PLANNING & ZONING COMMISSION
REGULAR MEETING
San Luis Council Chambers
1090 E. Union Street
San Luis, AZ 85349
Tuesday, May 10, 2016
7:00 P.M.

Discussion and possible action regarding Subdivision Case No. 2016-0158P. A request by Vega & Vega Engineering, PLC. on behalf of Comite De Bien Estar Inc., for the preliminary plat approval for Bienestar Estates 9A Phase 2. The property is located on the southwest corner of Avenue E 1/2 & County 23 1/2 Street, Assessor's Parcel No. 777-54-243, San Luis, Arizona.

I have reviewed the Bienestar Estates 9A Subdivision – Phase 2 Preliminary Plat and have the following comments:

Subdivision Case No. 2016-0158P
Comments of Development Services Department

PRELIMINARY PLAT

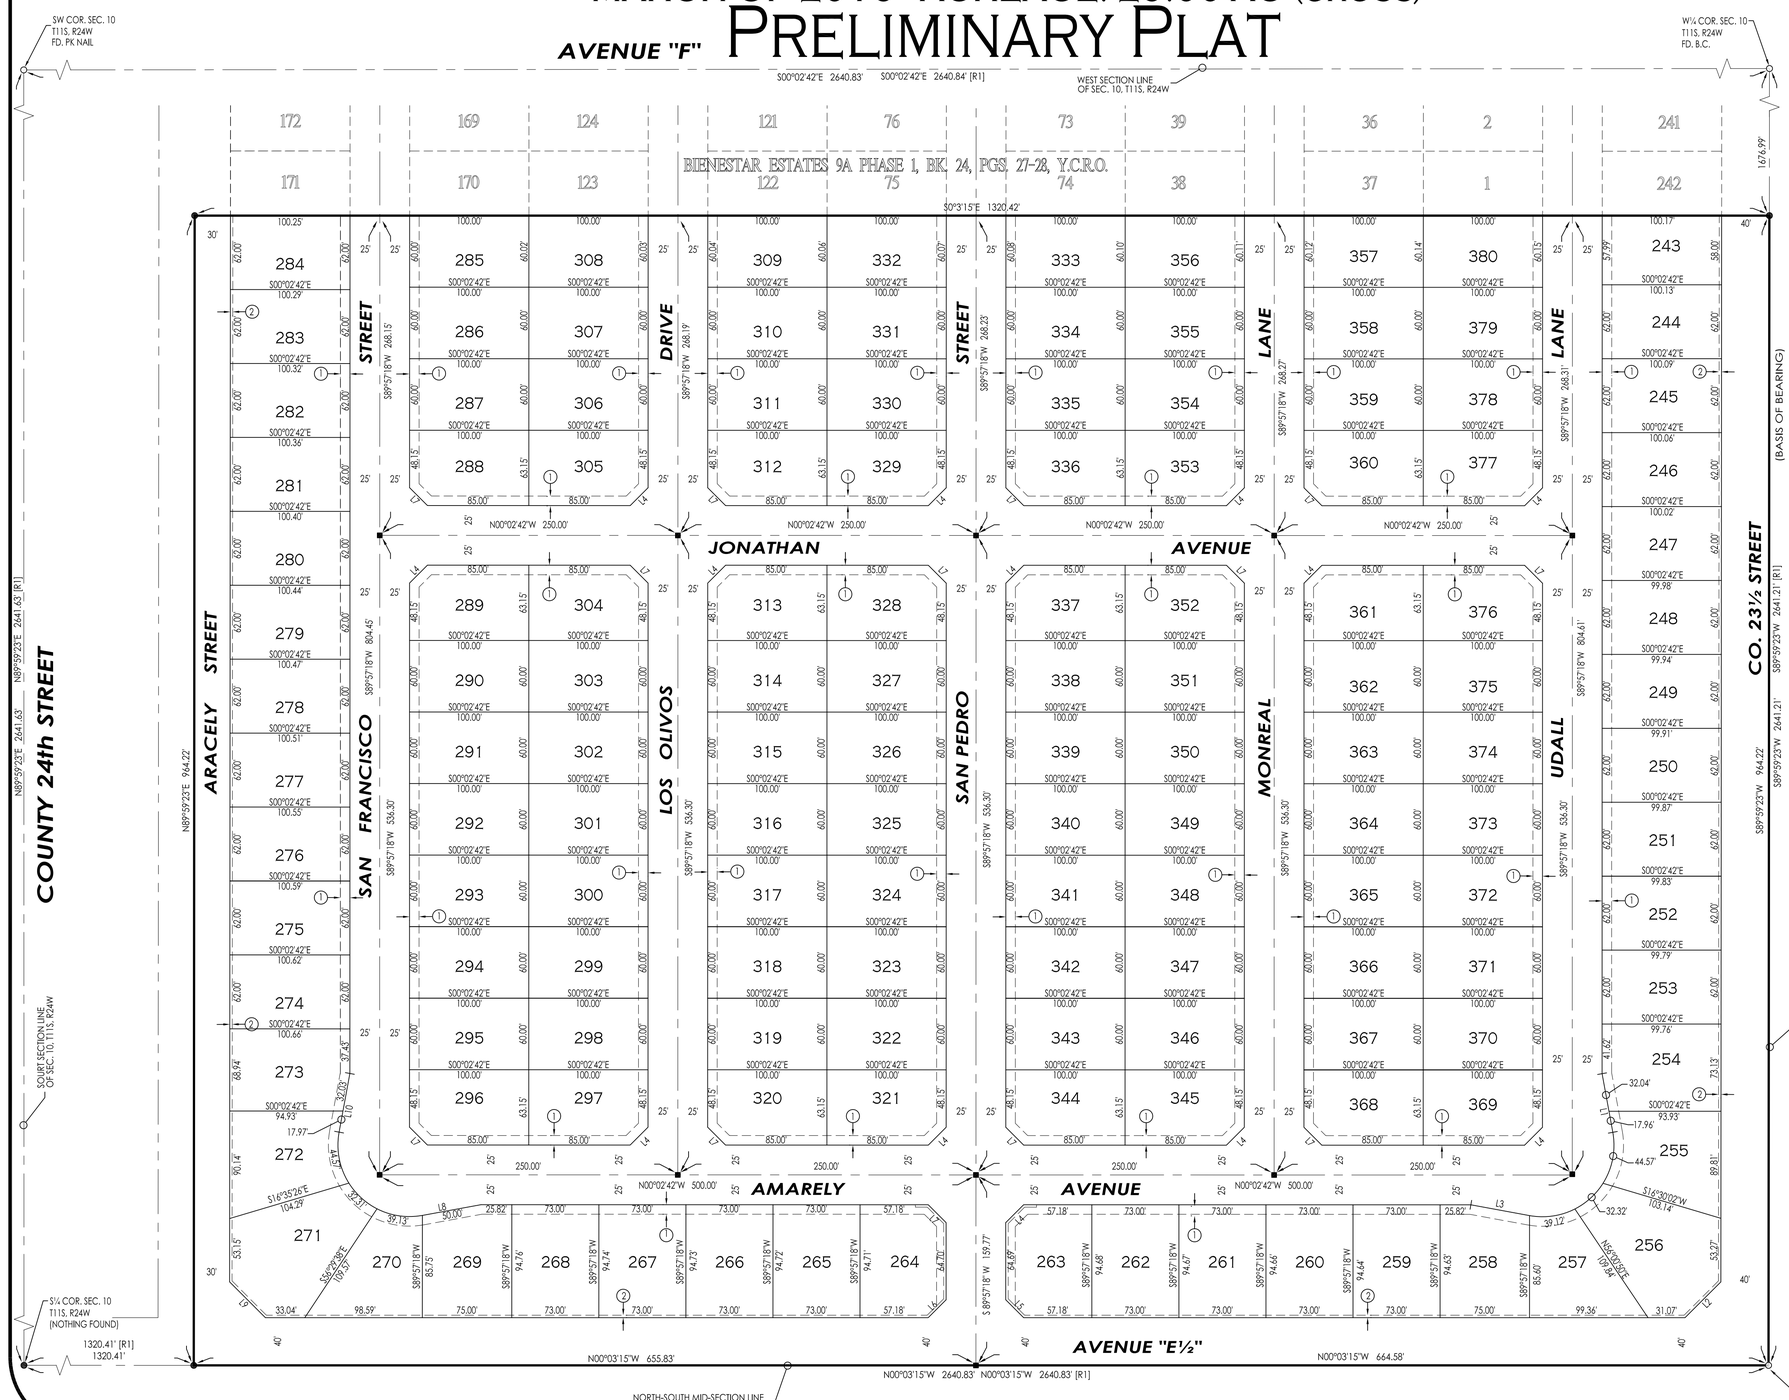
Cover – No Comments.
Preliminary Plat – Sheet 1

1. Survey monuments for the corners of the subdivision should be per Yuma Co. Detail 4-040 instead of 4-030 (all will be in pavement.)
2. Corner chamfers (sight triangles) at all interior street intersections are shown as being about 15' x 15'. This is the same dimension as used in Phase 1 of the subdivision and per the Preliminary Grading and Paving Plan the handicap ramps appear to fit with these chamfers, however the Yuma County Standard is 25' x 25'. *(Are 15' x 15' chamfers acceptable to the City given the precedence set by Phase 1?)*
3. Show adjacent street right-of-way along Avenue E-1/2 as has been dedicated to the City per the Border Ranches Subdivision Plat.

Preliminary Paving & Grading Plan
BIENESTAR ESTATES 9A PHASE 2

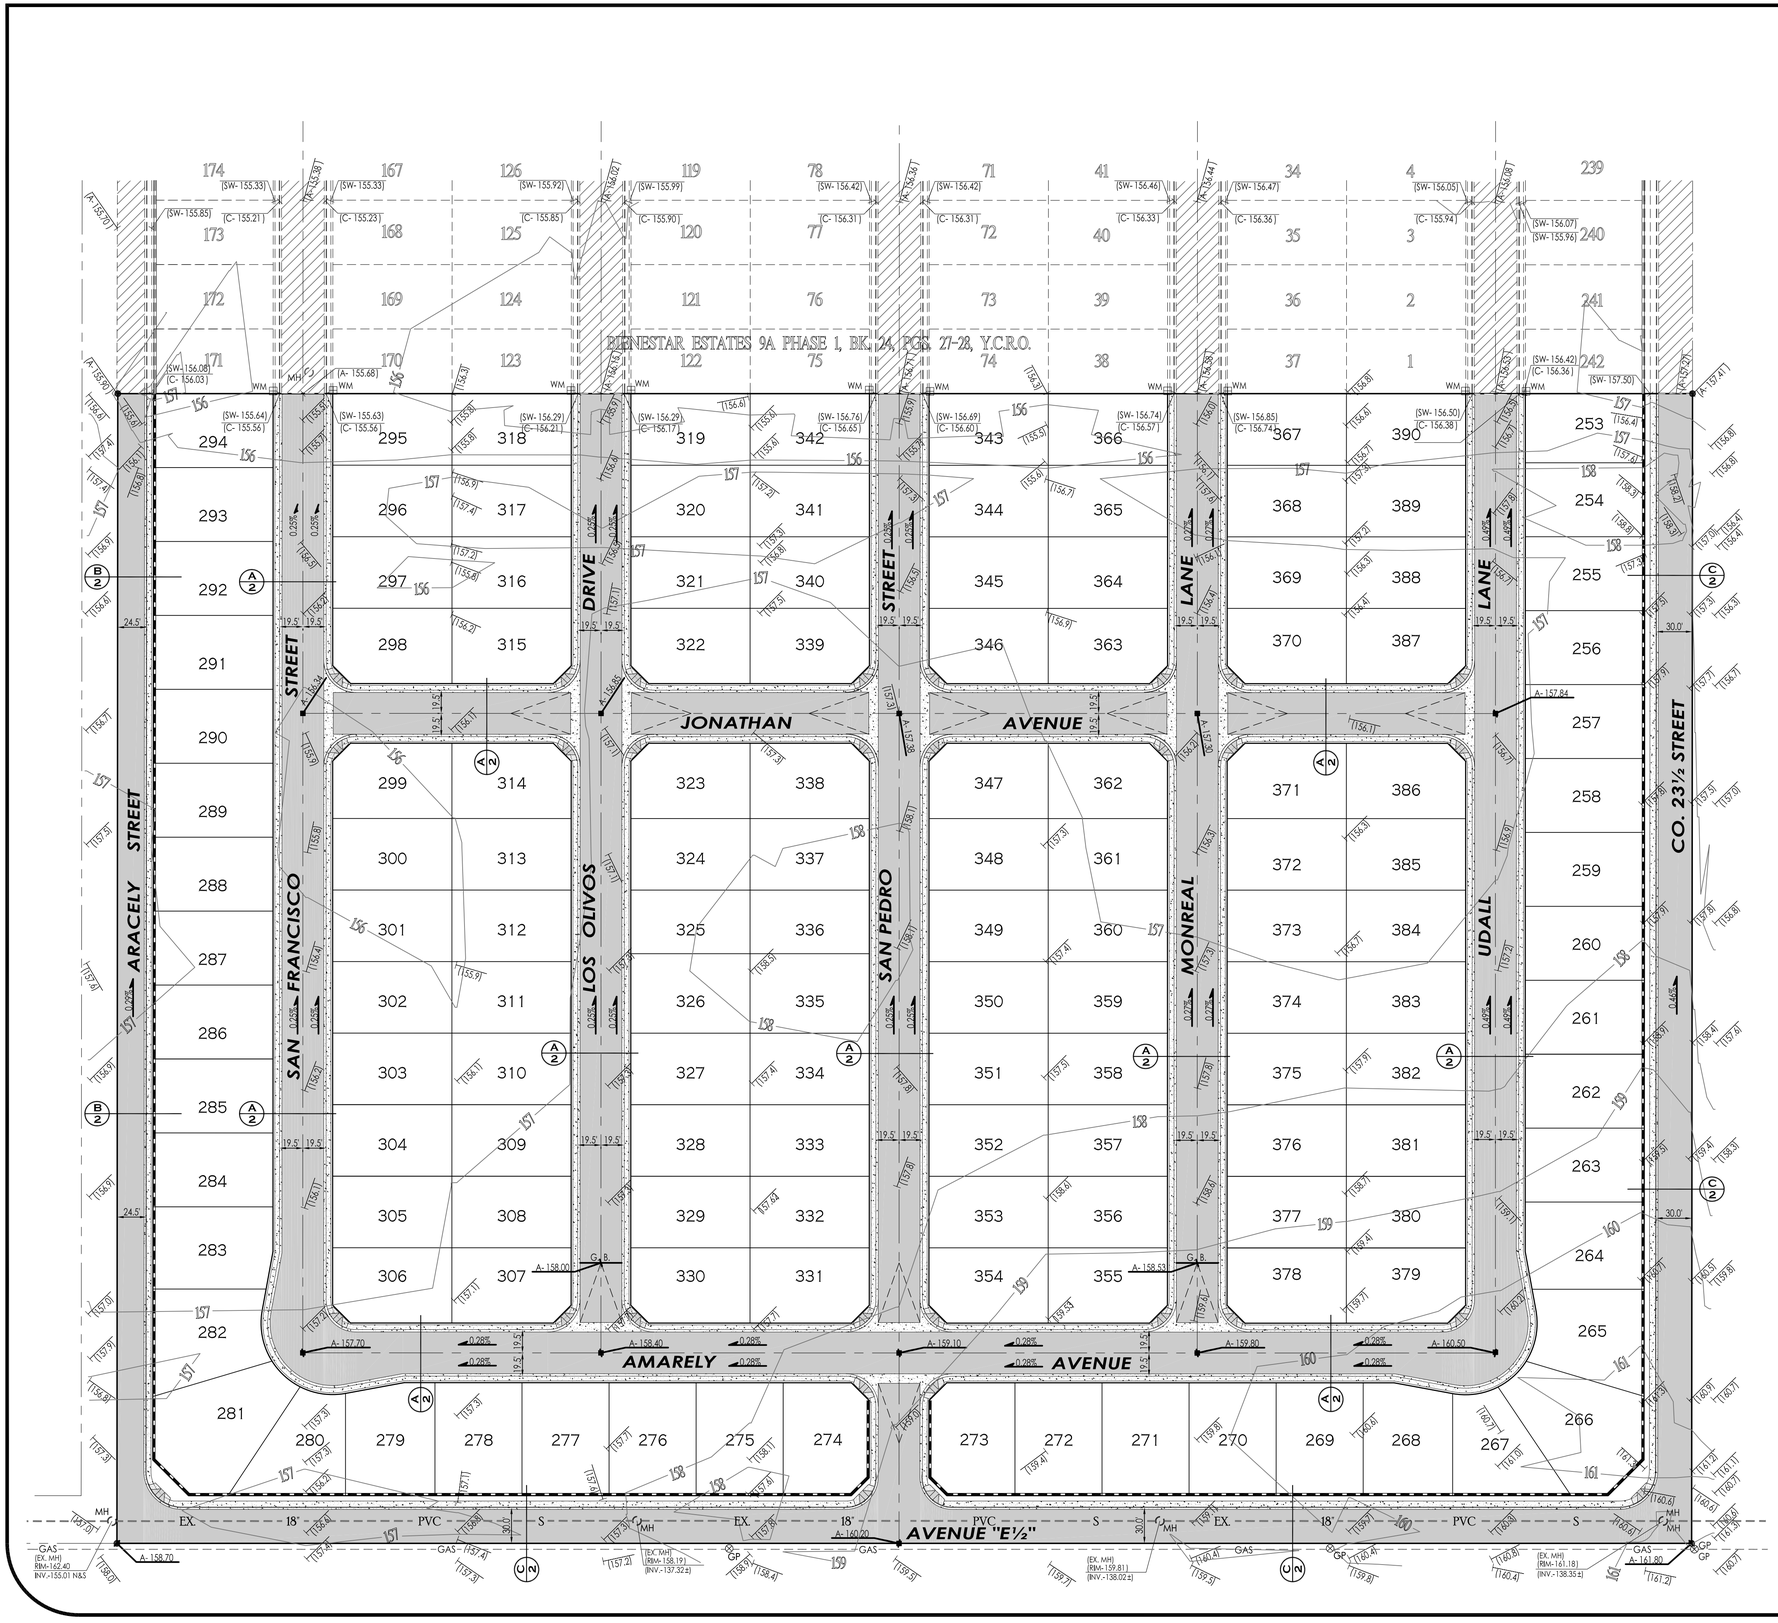
Preliminary Paving and Grading Plans – Sheet 1

1. Subdivision is shown to drain to the retention basin constructed in Phase 1. Provide an updated drainage report including updated retention basin sizing based on including runoff from Phase 2 and the as-built condition of the retention basin and including calculations of street flow capacities for the combined subdivisions.

Preliminary Water & Sewer Plan
BIENESTAR ESTATES 9A PHASE 2

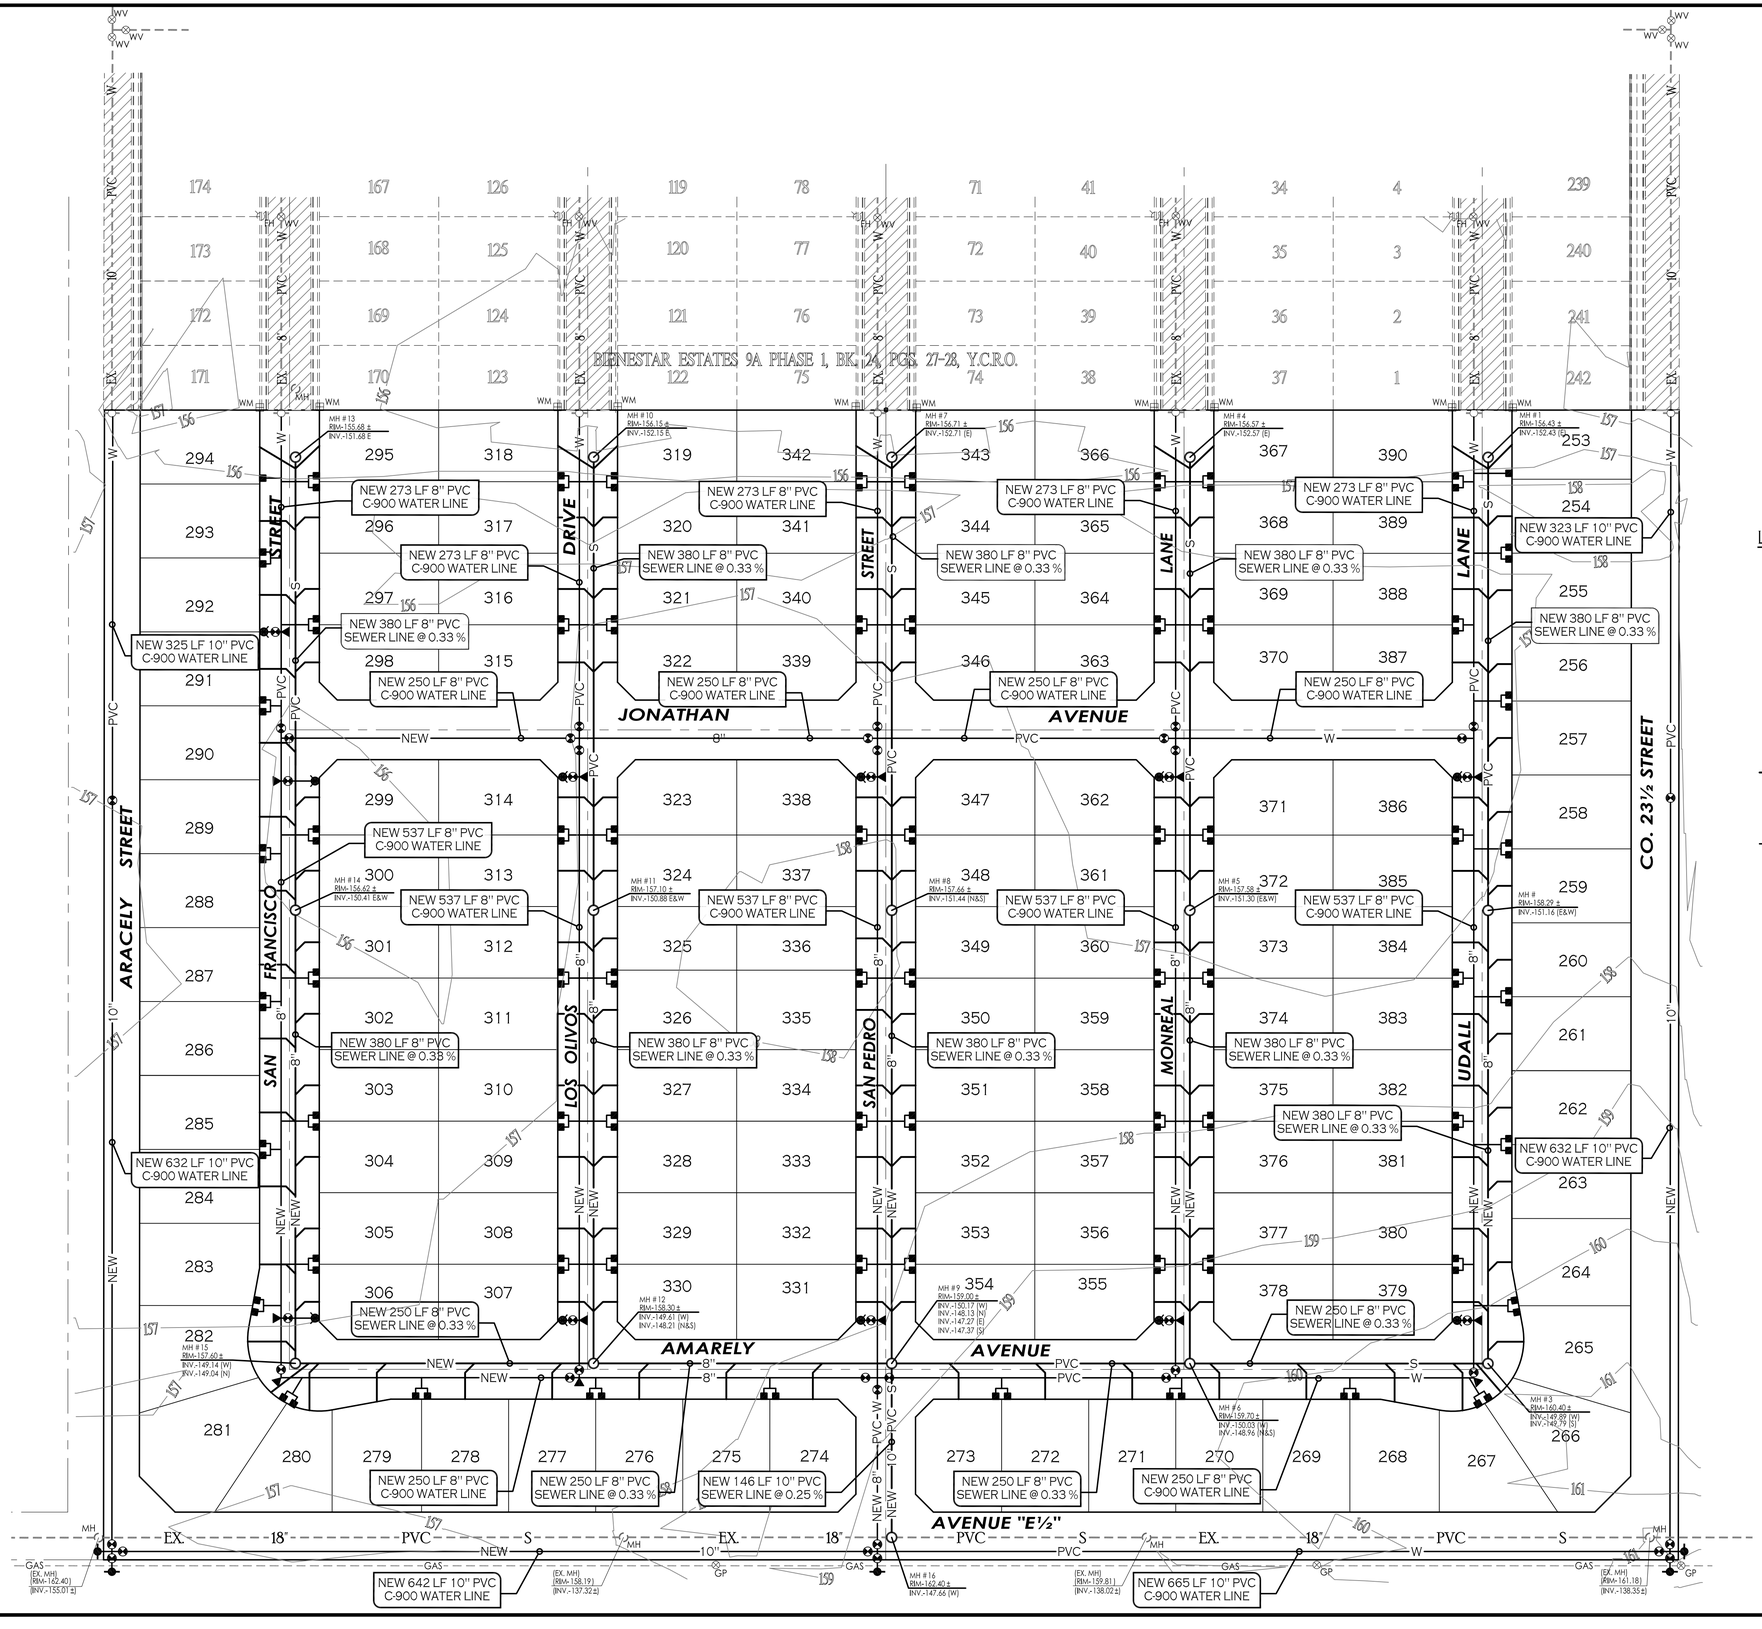
Preliminary Water and Sewer Plan – Sheet 3

1. Check grade of MH #9 – its east invert grade is lower than the invert grade of MH #16 downstream of it.
